Addendum No. 02

Issued: 9/13/2024

Project Name: Jordan Learning Center
Project No.: 2024528.00
Bid Package: 1

E3 SHRUB ON SLOPE 5% (20:1) TO 50% (2:1) - UNMODIFIED SOIL
 3/4" = 1'-0"

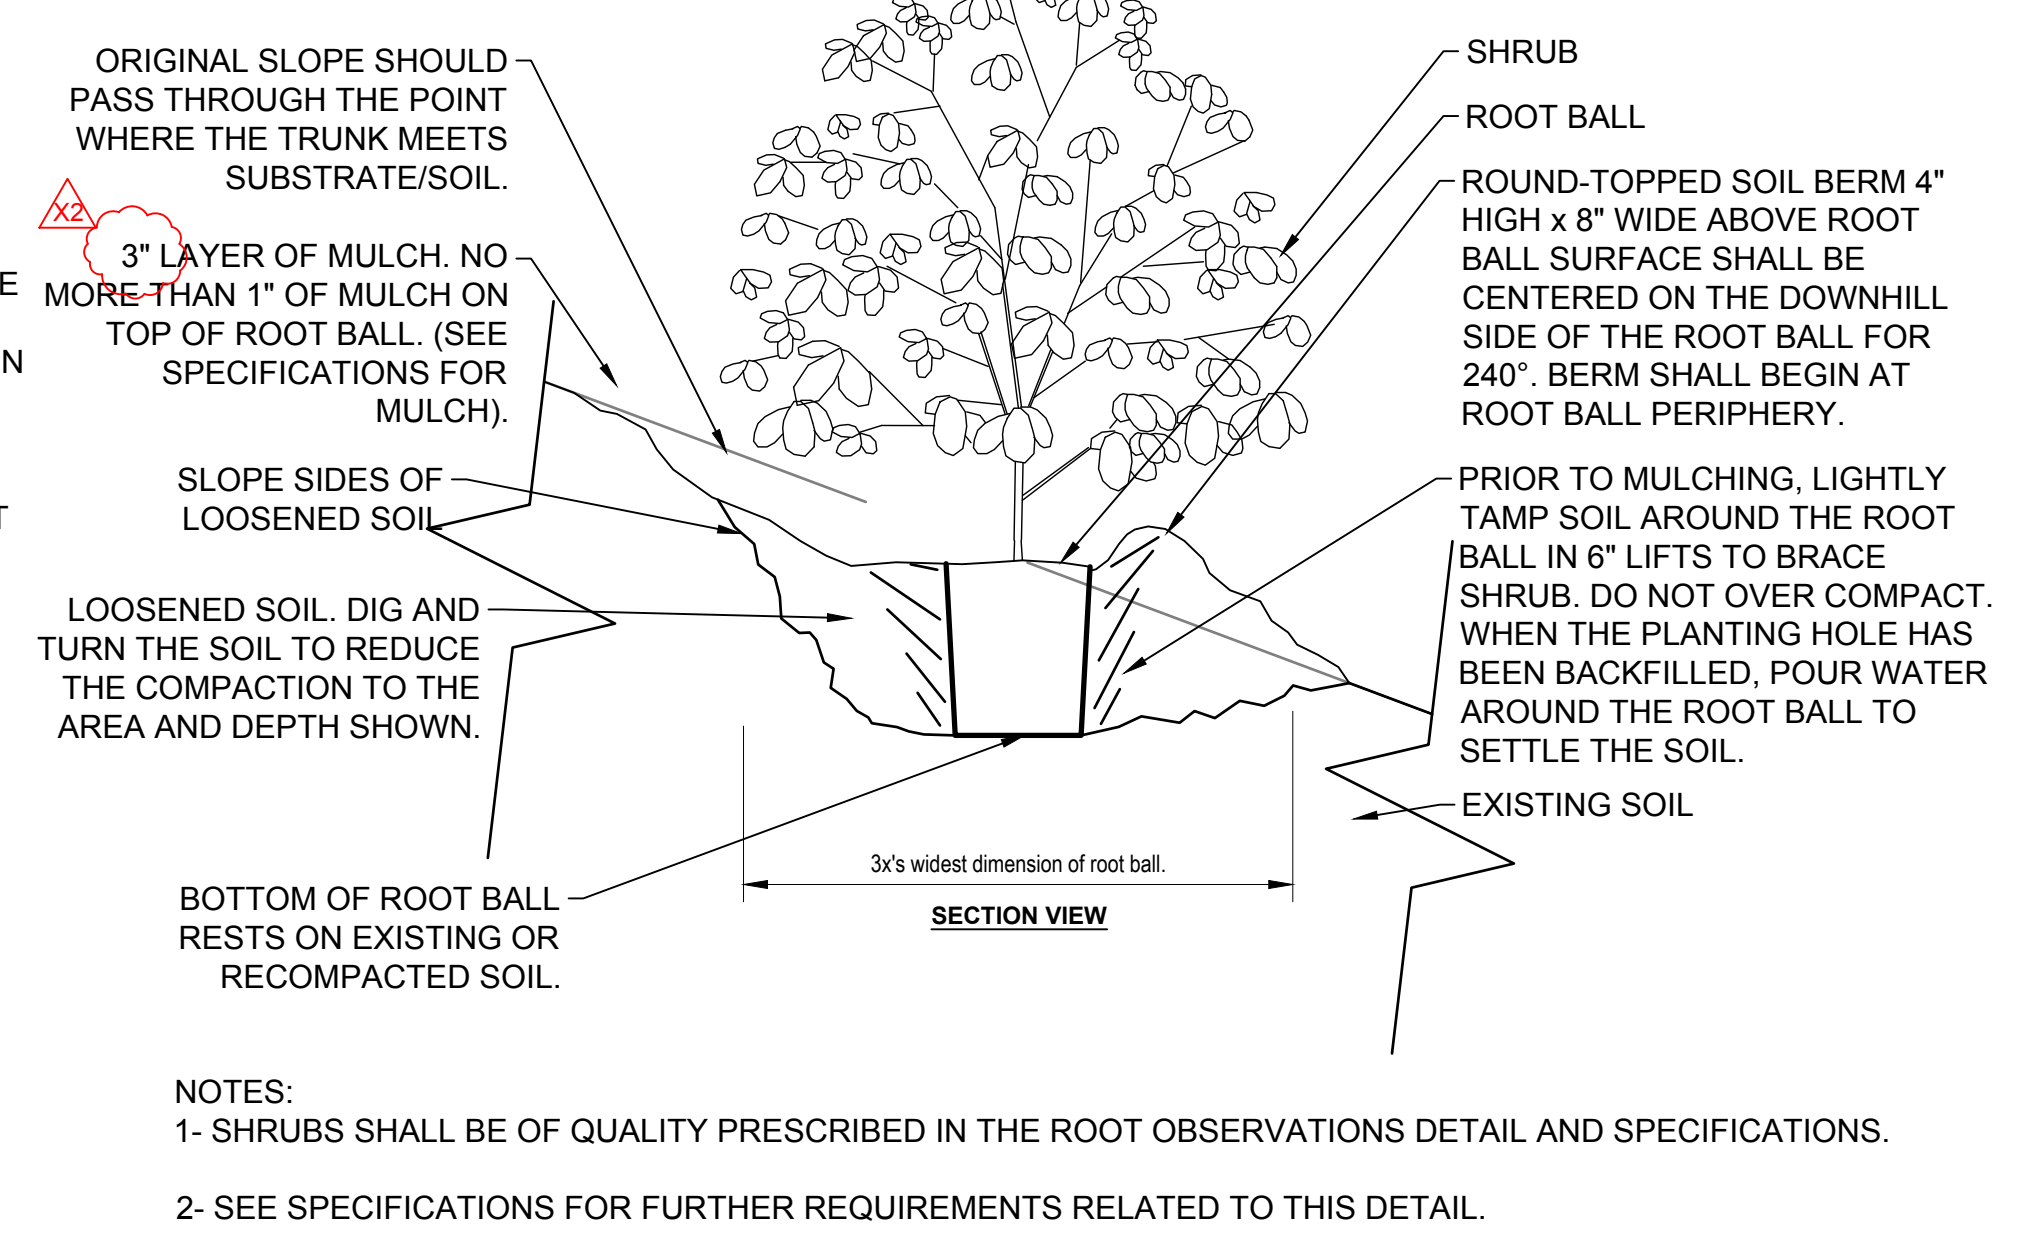
- Removed planting schedule from sheet.
- Revised details D1, D3, E2, E3, to have 3" mulch depth requirements.
- Refined planting notes.

A3
SB502
 RUST REPAIR ON EXIST EXTERIOR HSS COLUMN
 NO SCALE

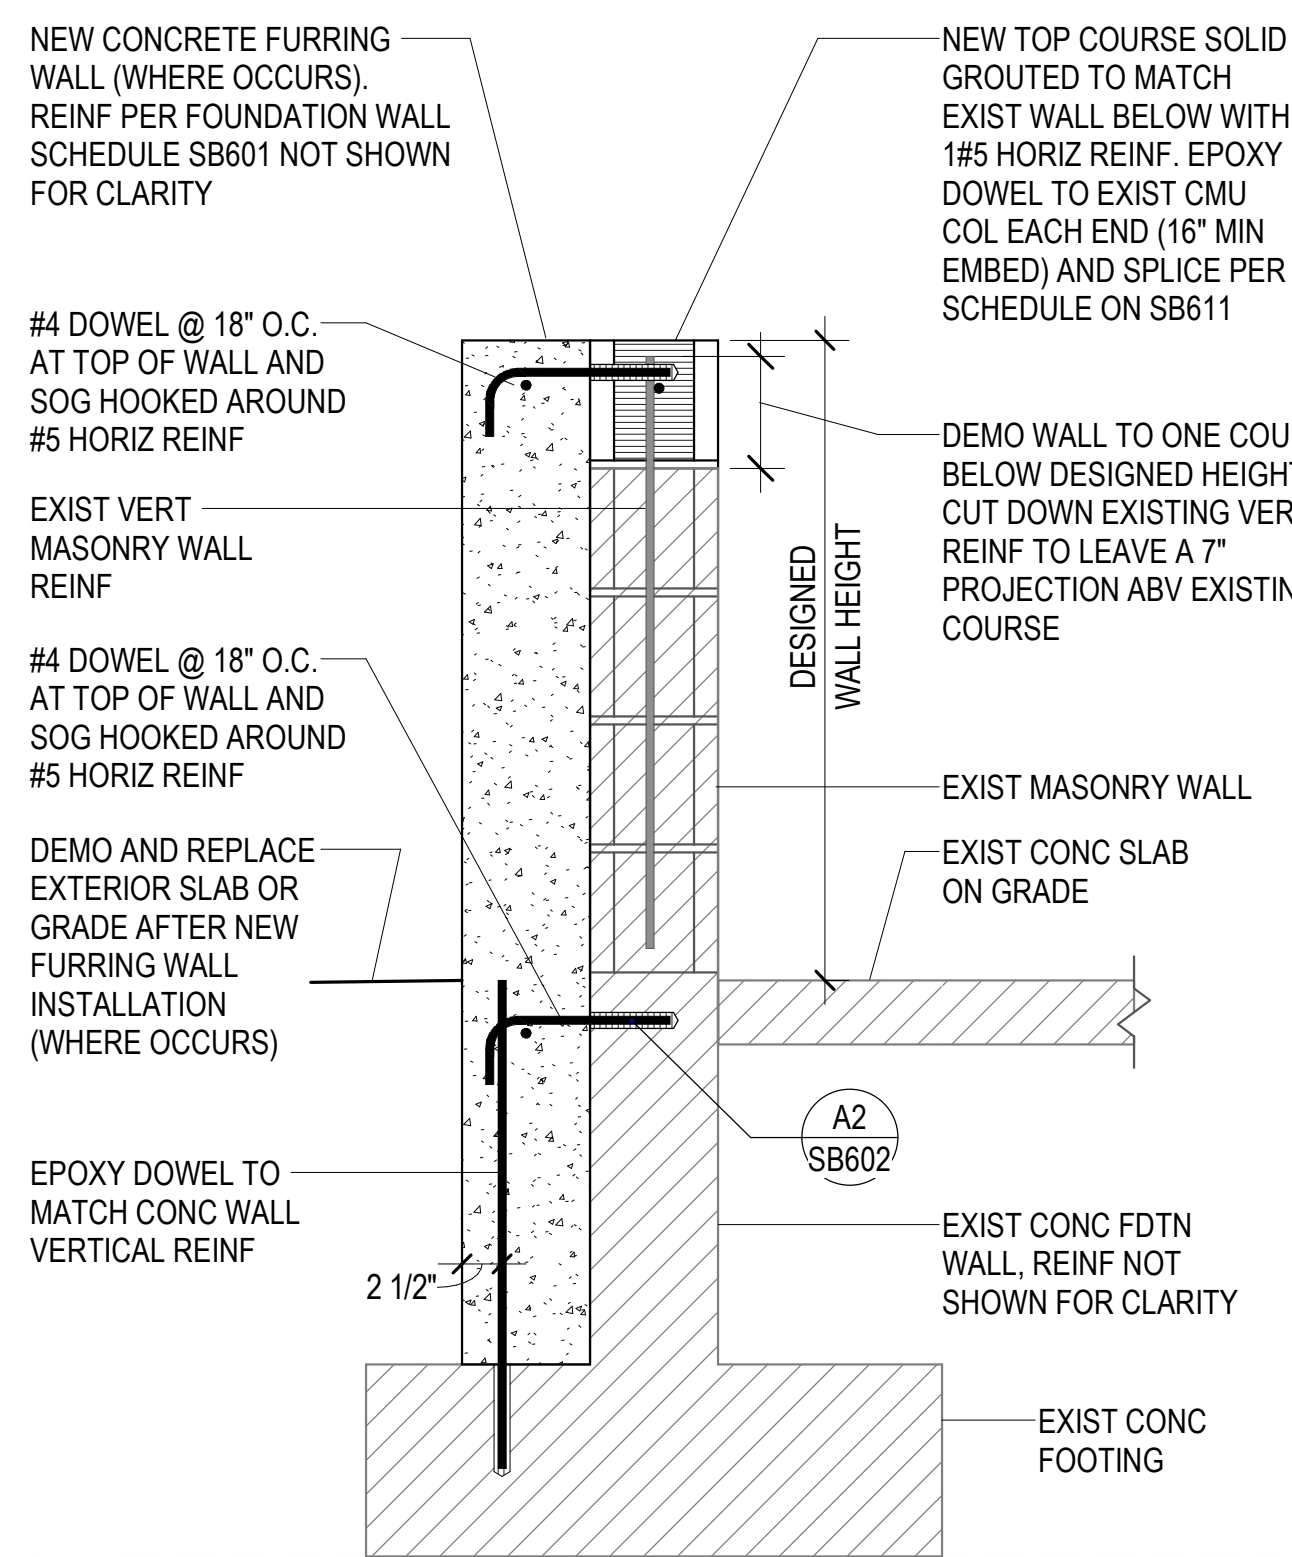
- Updated detail A3 for added furring concrete wall.

SF101A

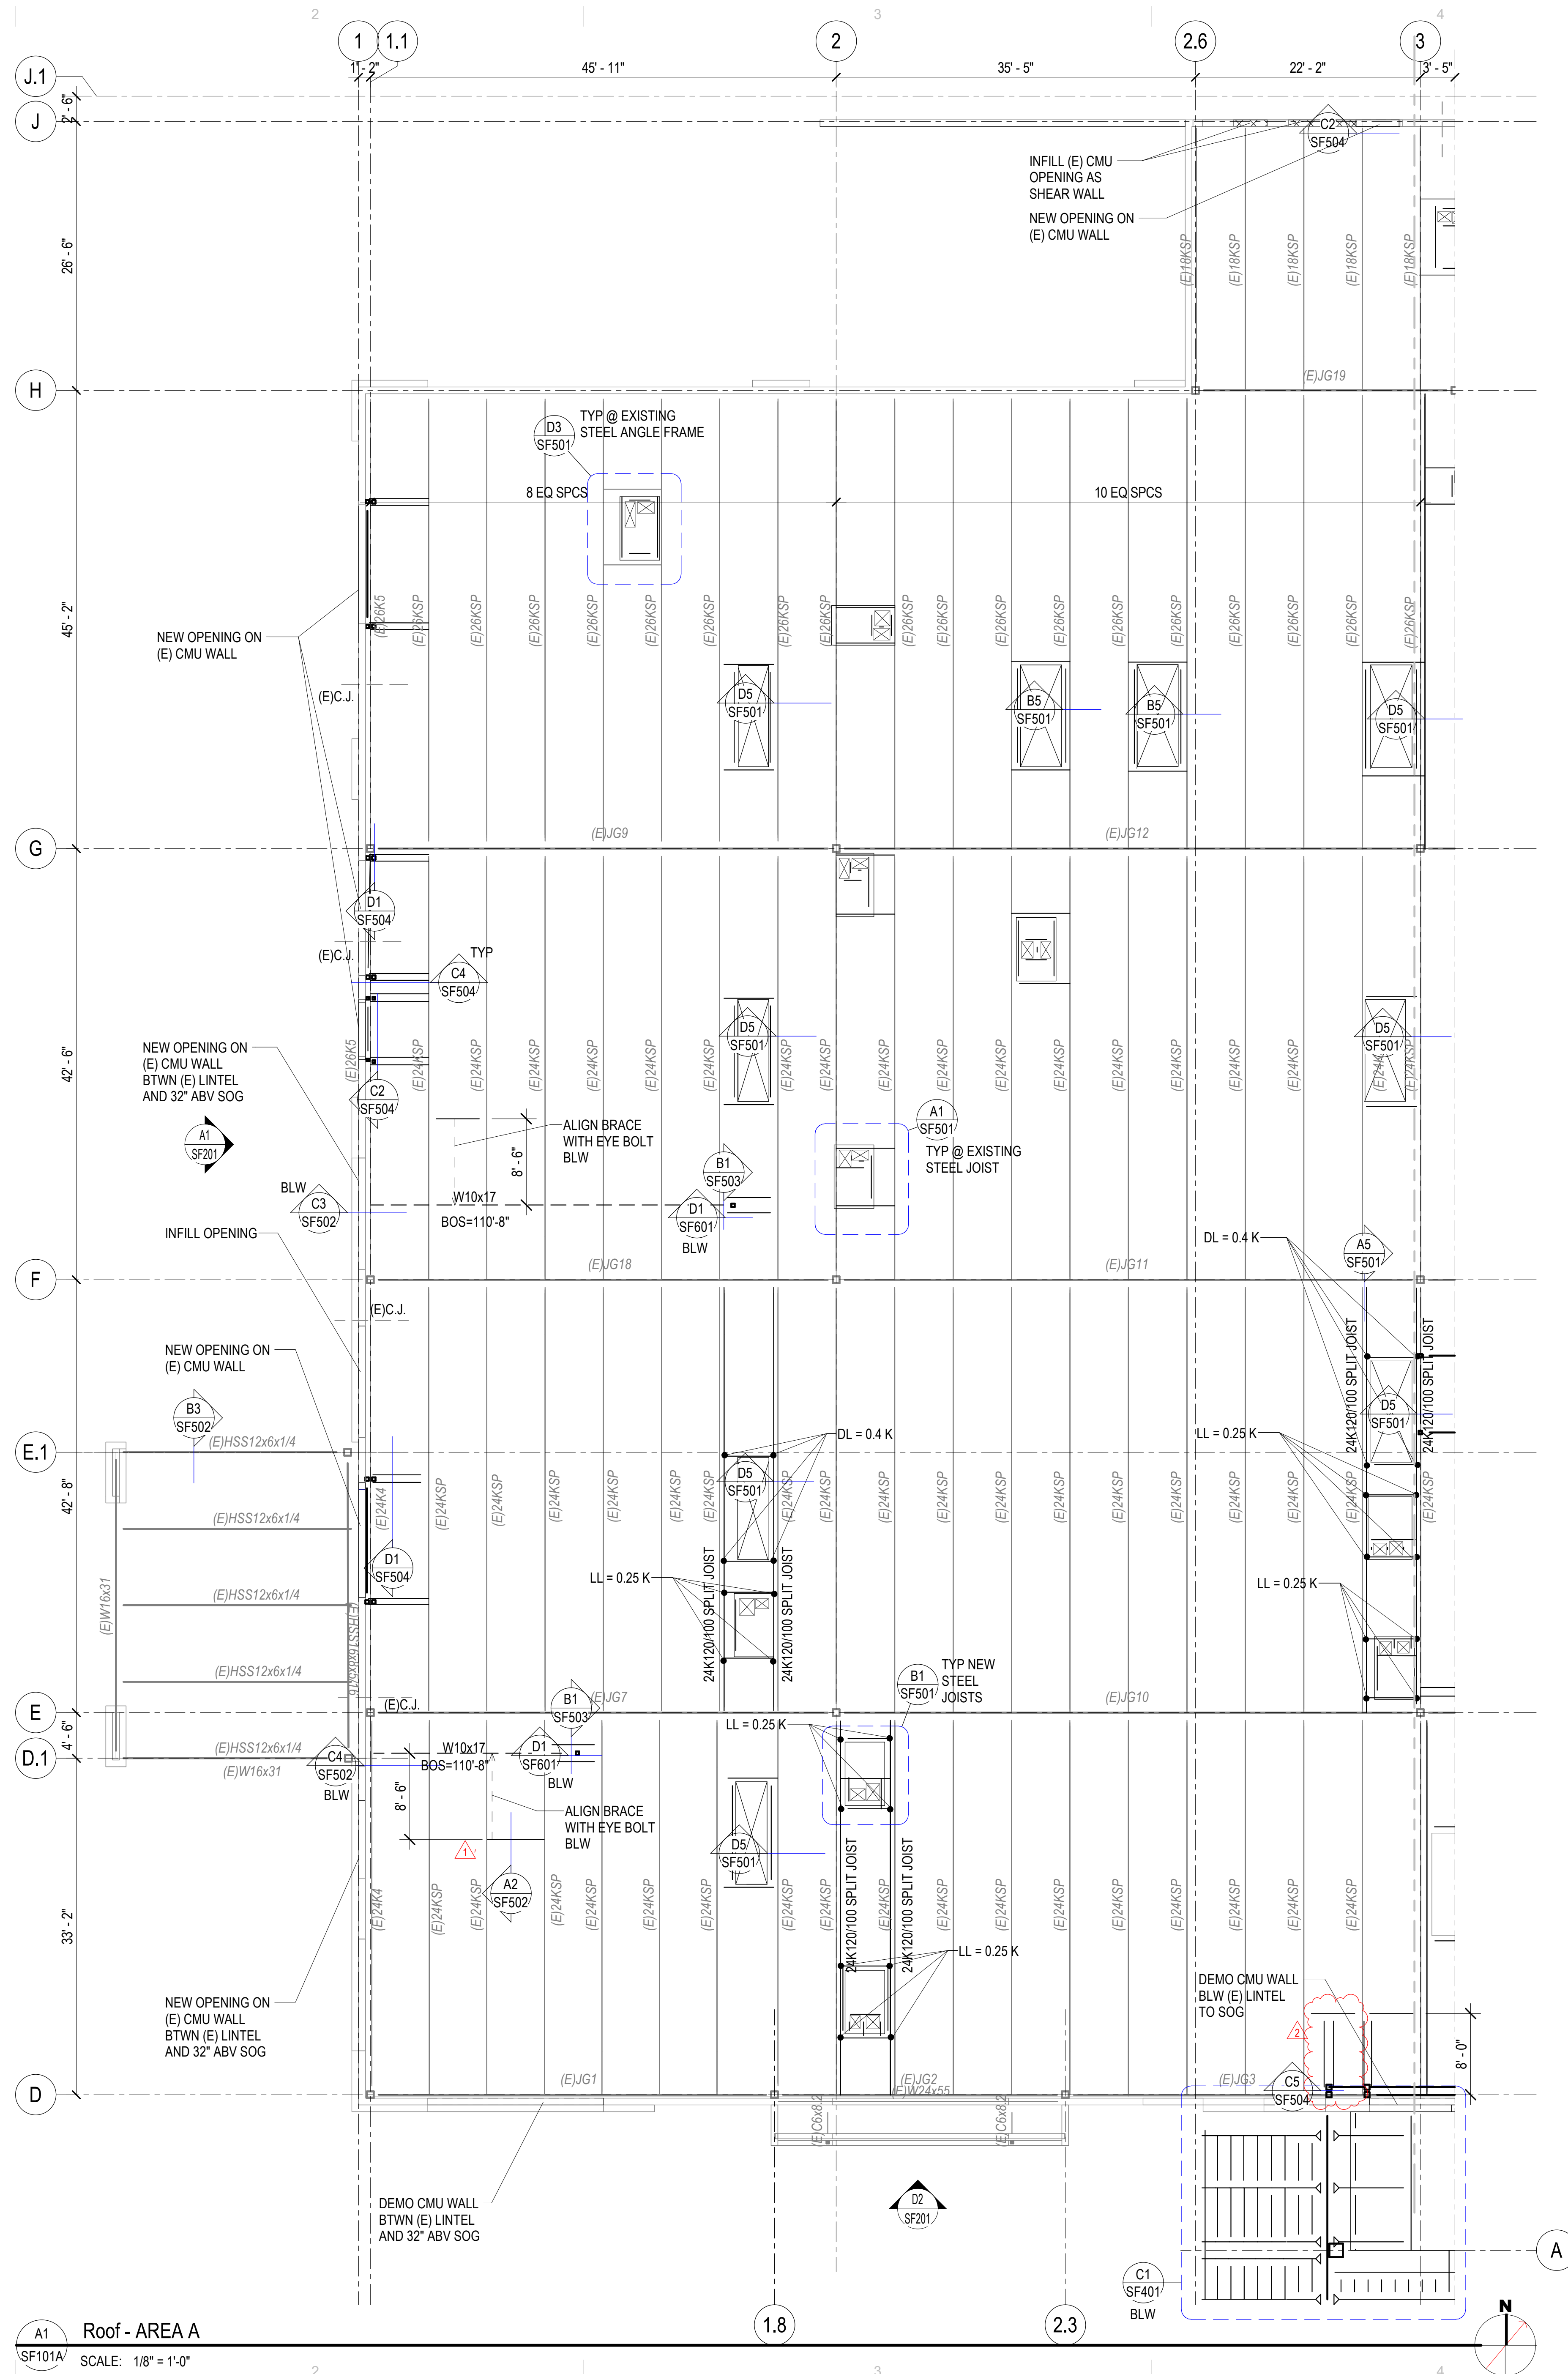
- Added setback tube columns and HSS lateral support to the opposite side of the CMU wall for canopy.
